Item ID: D412-664-203

Item Name: Crosstube Aft

DRAWING NO. D412-664-243	TITLE CROSSTUBE ASSEMBLY (412 HI AFT)	REV. E	DART AEROSPACE LTD ENGINEERING ORDER		D.E.O. NO. D412-664-243-E-1	SHEET NO. SHEET 1 OF 2	SCALE NTS
DRAWN	CHECKED	MFG. APPR.	APPROVED	DE APPR.			
DATE 11.03.31	DATE 11/03/31	DATE 11.03.31	DATE 11/03/31	DATE 11.03.31

DRAWING NO. D412-664-243	TITLE CROSSTUBE ASSEMBLY (412 HI AFT)	REV. E	DART AEROSPACE LTD ENGINEERING ORDER	D.E.O. NO. D412-664-243-E-1	SHEET NO. SHEET 2 OF 2	SCALE NTS
DRAWN	CHECKED	MFG. APPR.	APPROVED	DE APPR.		
DATE 11.03.31	DATE 11.03.31	DATE 11.03.31	DATE 11.03.31	DATE 11.03.31

**D412-664-243
ASSEMBLY DETAIL**

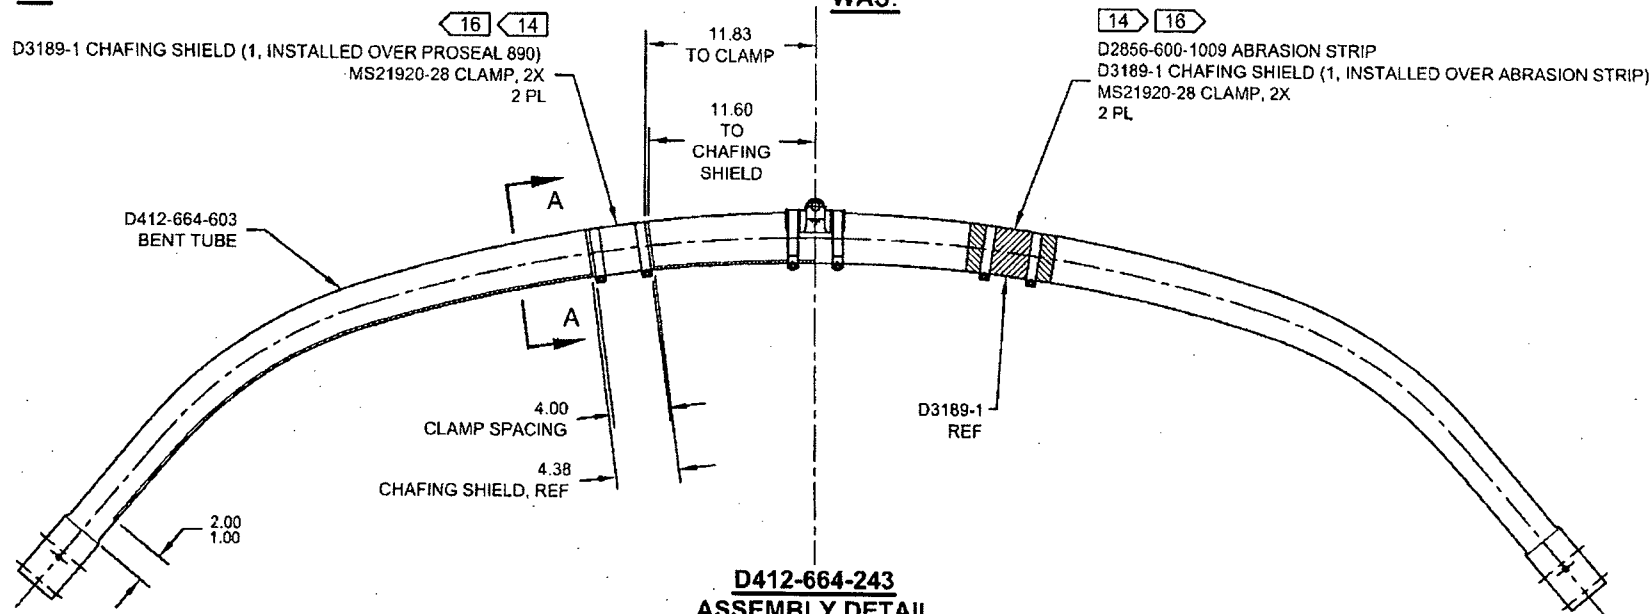
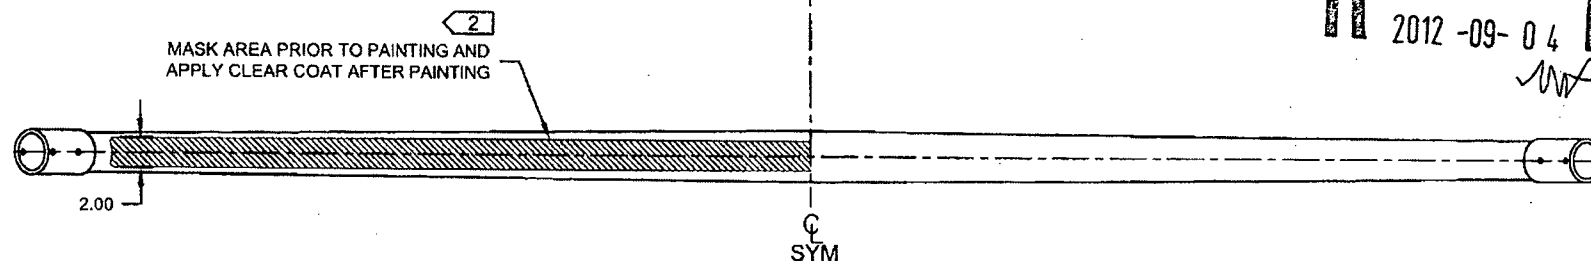
IS:

D3189-1 CHAFING SHIELD (1, INSTALLED OVER PROSEAL 890)
MS21920-28 CLAMP, 2X
2 PL

WAS:

D2856-600-1009 ABRASION STRIP
D3189-1 CHAFING SHIELD (1, INSTALLED OVER ABRASION STRIP)
MS21920-28 CLAMP, 2X
2 PL

SECTION A-A
CHAFING SHIELD DETAIL
VIEW ROTATED, NOT TO SCALE

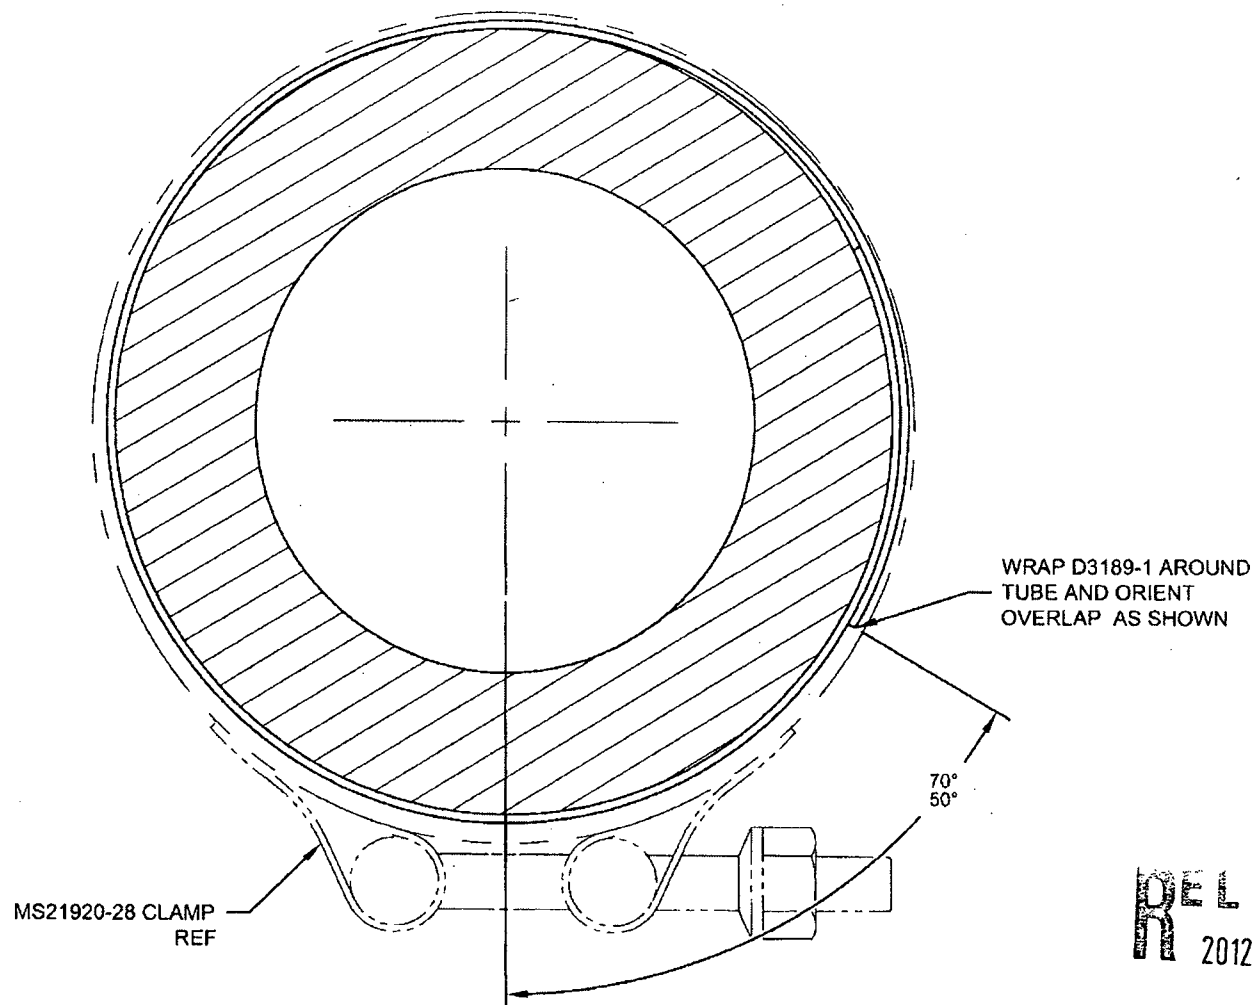
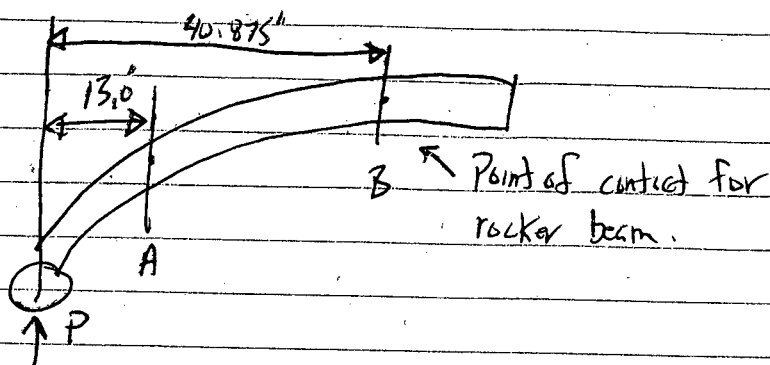
DRAWING NO. D412-664-243	TITLE CROSSTUBE ASSEMBLY (412 HI AFT)	REV. E	DART AEROSPACE LTD ENGINEERING ORDER		D.E.O. NO. D412-664-243-E-4	SHEET NO. SHEET 3 OF 3	SCALE NTS
DRAWN 92	CHECKED	MFG. APPR.	APPROVED	DE APPR.			
DATE 12.08.21	DATE 12.08.27	DATE 12.08.29	DATE 12.08.29	DATE 12.08.29	DATE 12.08.29
